**STAFF REPORT
FOR THE PLANNING COMMISSION**

FILE NO: CUP-10-03/DR-10-06/VAR-10-05/VAR-10-07/VAR-10-06/
VAR-10-08/WA-10-01

HEARING DATE: November 3, 2010

REQUEST: Conditional Use, Class II Design Review, four Class II Variances and Water Resource Area Protection permit approval for the construction of an elementary school and associated facilities and access. The site is located east of Rosemont Road and north of Hidden Springs Ranch #8, phases 3 and 5.

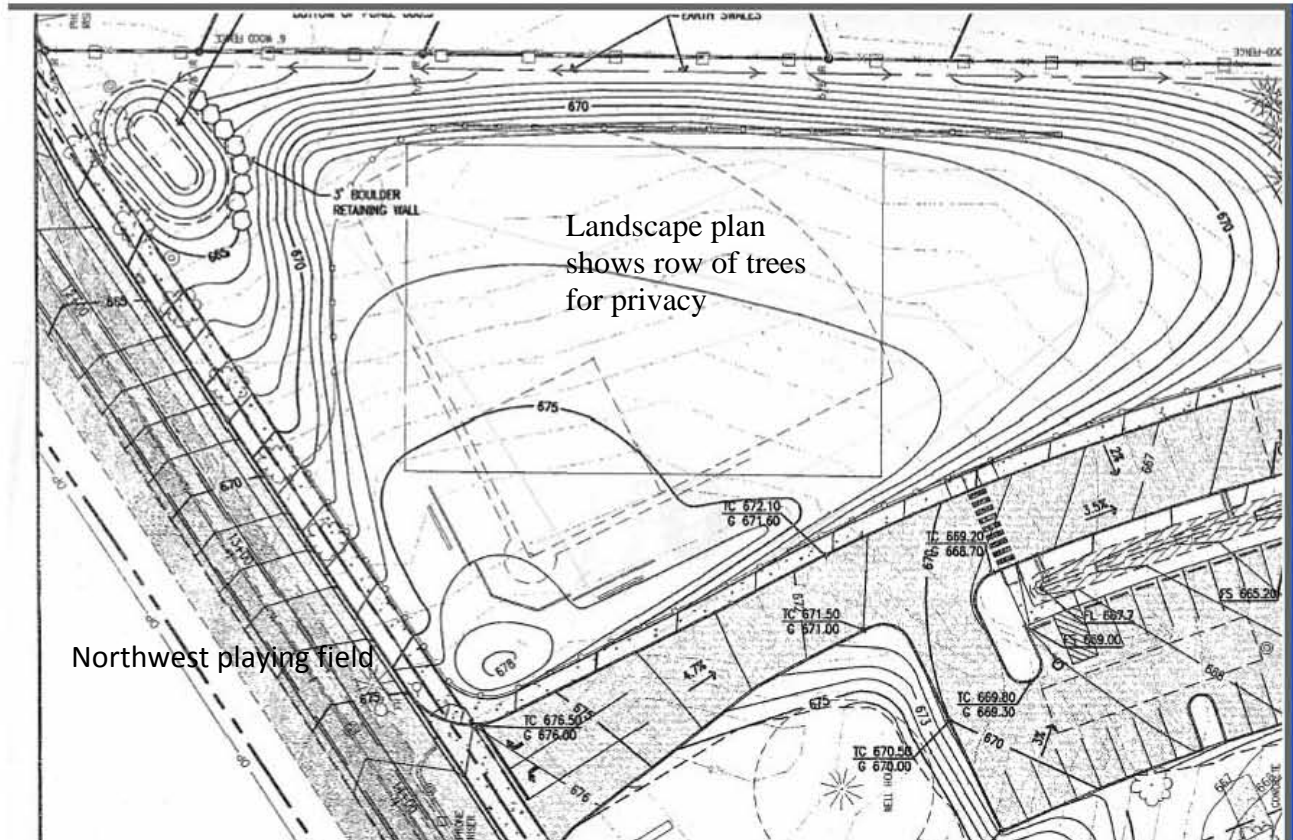
Homes in the Arena Park subdivision could see impacts, such as loss of privacy, in that the existing grade will be raised seven to ten feet to accommodate a softball field. Another problem with this playing field is that the distance from home plate to the homes is about 180 feet meaning that an advanced sixth grader could, according to the City Parks Department, hit a ball into the abutting rear yards (see illustration below).

By changing the programming of that field to general play from softball the “broken rear window threat” is removed and by increased vegetative screening at the north edge of the fill, the privacy concerns are addressed. Thus the criterion is met.

Figure 8-6 of the TSP shows a connection from Suncrest Drive to Bay Meadows Drive

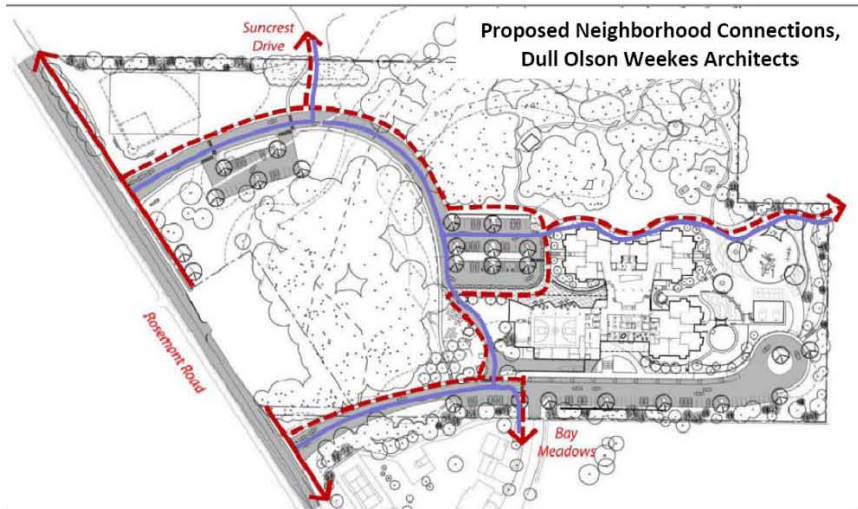
Initially it was thought that the school's lack of a street connection between Suncrest Drive and Bay Meadows Drive constituted a failure to meet the TSP as shown in Figure 8-6. That would have required a TSP amendment per section 60.090(C) above. The City Attorney was consulted and stated that findings should be made to determine if the elimination of the connection for motorized vehicles creates enough of an impact that an amendment to the TSP is required. The City's Engineering Department retained Kittelson Engineering to provide an independent review of the applicant's consultant's (DKS) findings.

DKS found, and Kittelson concurred, that circulation and connectivity would not be significantly compromised since the stub out from Suncrest Drive is only 450 feet away from Rosemont Road and Bay Meadows is only 420 feet from Rosemont Road. That means that a trip from one subdivision to the other by car only adds 870 feet going by Rosemont Road. It is expected that most trips between these neighborhoods will be on foot or by bike through the school site since the distance is so short.

Kittelson and staff also found that although motorized vehicular connection is not proposed by the School District between Suncrest and Bay Meadows Drives, connections are being provided along this corridor for pedestrian and bicycle traffic. Connections for emergency vehicles are partially offered via an emergency vehicle only gate at Bay Meadows Drive. Thus, only non-emergency vehicle use would be excluded from this corridor. Since three out of four modes of transportation are being accommodated, a finding can be made that the proposal is consistent with the TSP in that a connection is provided.

A north to south connection would confuse the circulation pattern by crossing the two east to west access driveways and allow for mixing of traffic types (staff vehicles, buses, parents, visitors and through traffic) which is something the district and the city want to avoid.

Another flaw associated with building a connection per figure 8-6 (above) would be the faster speeds associated with through traffic between Suncrest Drive and Bay Meadows Drive. Higher speeds increase the hazard for the small children who will be attending this school as well as increasing the potential for vehicle-vehicle crashes. This potential hazard could discourage parents from allowing their children to walk or bike to school which would work against the “Safer Routes to School” program, child health and the TPR.

Winzler and Kelly's bus turning simulations comparing curb radius:

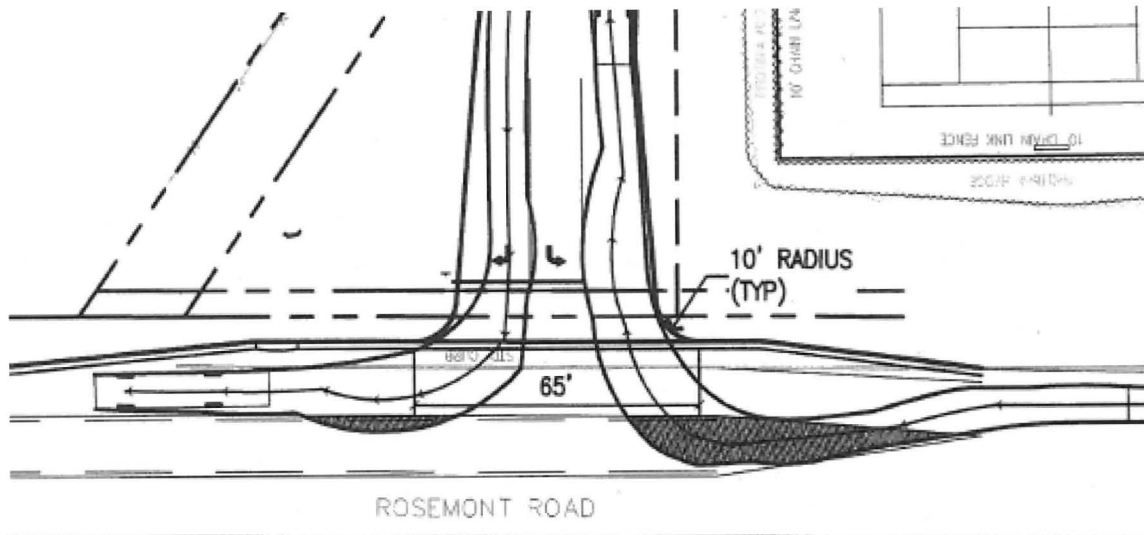
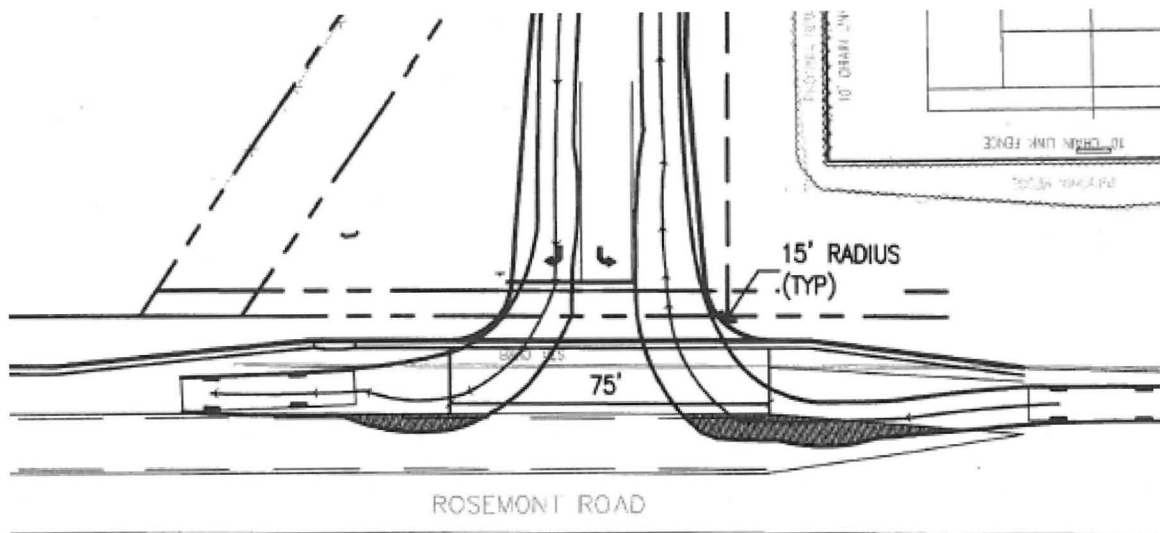
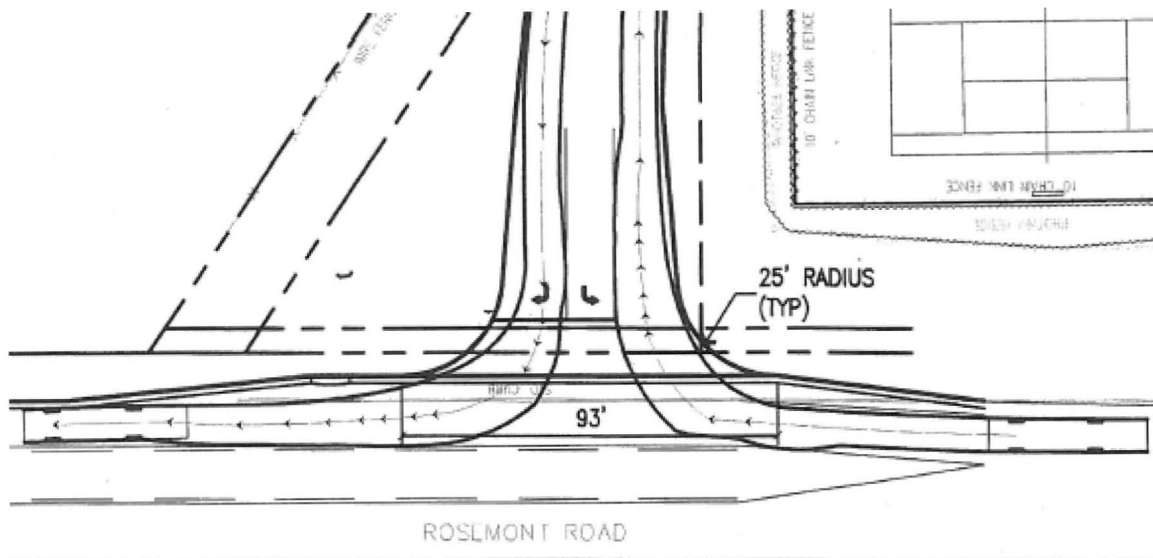
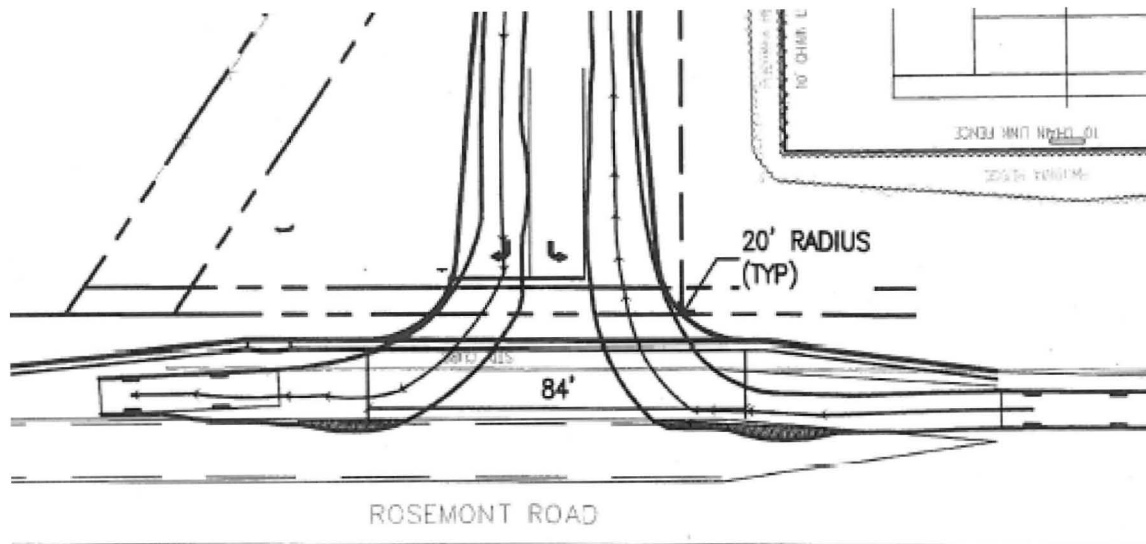
Staff finds that the applicant has presented arguments in the July 7, 2010 submittal that the 25-foot curb radius is necessary. Graphic evidence of this is shown in Winzler and Kelly's bus turning simulations below. The simulations show the movement of the school buses entering and leaving the site with a 10, 15, 20 and 25 foot curb radius (25 foot curb radius yields the 95 foot wide curb cut). The 10 foot radius shown below indicates that buses entering the site would have to swing about 15 feet out of the travel lane into the center turn lane to make the turn movement. Exiting turn movements would stray out of the travel lane too, but not as dramatically. Designs with curb radius of 15 and 20 feet would also be forced out of their travel lanes but the 20 foot radius forces only a very minor deviation. Of the four examples, only the 25 foot radius is adequate to allow the buses to stay in their lanes when making the turn. Staff finds that these simulations constitute compelling evidence of exceptional circumstances that justify the curb cut width variance but only at the south driveway.

The north driveway has similar issues for cars exiting and entering the site but because cars, SUVs and mini-vans are shorter, the curb radius can be reduced. Staff proposes 15-foot radius to yield a total curb cut of 66 feet (36 feet plus 30 equals 66).

To address this hazard, first, the curb cut curb radii should be the minimum width necessary to allow reasonable ingress/egress; and second, speed tables (see photo on page 53) at both driveways should be installed to clearly identify the pedestrian crossings, slow down traffic and improve public safety. Staff finds that a 15-foot curb radius at the north driveway and a 25-foot curb radius at the south driveway provide appropriate facilities for the different types of vehicles (buses, cars, etc.) so long as measures to better protect pedestrians at the crosswalk are put in place too. The raised speed tables/crosswalks should accomplish that. Thus the criterion can be met by condition of approval 7.

Variance 2 Eastern Water Resource Area Setback

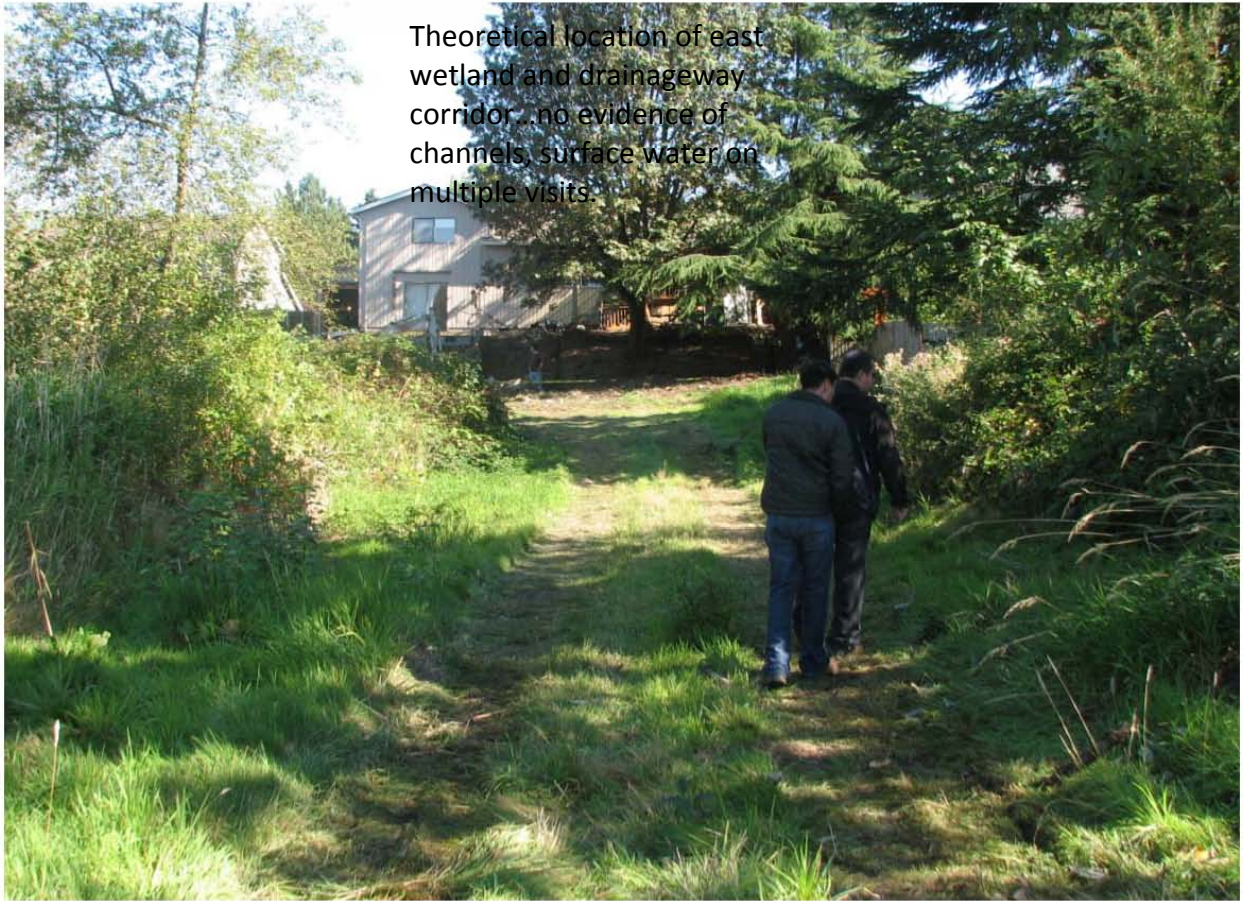
Ordinarily, staff would take a position of opposition to both the relocation of a wetland and reduction of the transition area, but in this instance, staff finds that the quality of the “WRA” is negligible. There is no discernable channel or drainageway along the 416 feet between the storm water outfall and intake points. Instead, the water flows seasonally in sheet fashion across the field and in extremely modest amounts. (*Staff visited the site multiple times through the winter 2009-2010 and saw no visible surface water or channels of any dimension even near the storm intake.*) The proposed mitigation involves creation of a drainageway channel with appropriate wetland vegetation.
